**Project Address:** 801 Erin Street  
**Application Type:** Demolition and Rezoning  
**Legistar File ID #:** [31423](#) and [31545](#)  
**Prepared By:** Heather Stouder, AICP, Planning Division  
 Report Includes Comments from other City Agencies, as noted

**Project Updates and Additional Information**

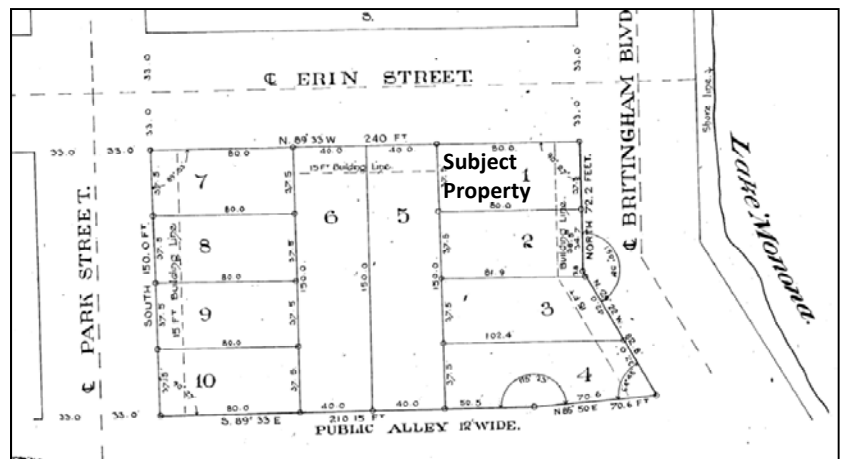
Further, as mentioned by City Engineering staff in Condition No. 2, the Spohn-Levander Replat for this block, which was approved in 1917, actually set a 15-foot "building line" on the eastern edge of these properties, facing West Shore Drive and Monona Bay (see figure at right). This line impacts the three existing homes on this block (Lots 2 and 3 have since been combined), but was not adhered to by the existing house on the subject property. The main front wall of the proposed home will bring this back into compliance.

1. The site plan indicates that the flagstone retaining wall that encroaches a foot or so into Erin Street and West Shore Drive is to remain in its current location. The retaining wall shall be removed from the public right-of-way.
2. The plat of Spohn–Levander Replat of Block 25 Greenbush Addition denotes a 15 foot "Building Line" set back from West Shore Drive. This is also shown on the site plan. The consultant/owner shall confirm with City of Madison Zoning Staff that the proposed new improvements are in conformance with any City of Madison required setbacks.
3. The new house will face West Shore Drive. A new address of 702 West Shore Dr was created 7/25/2013.
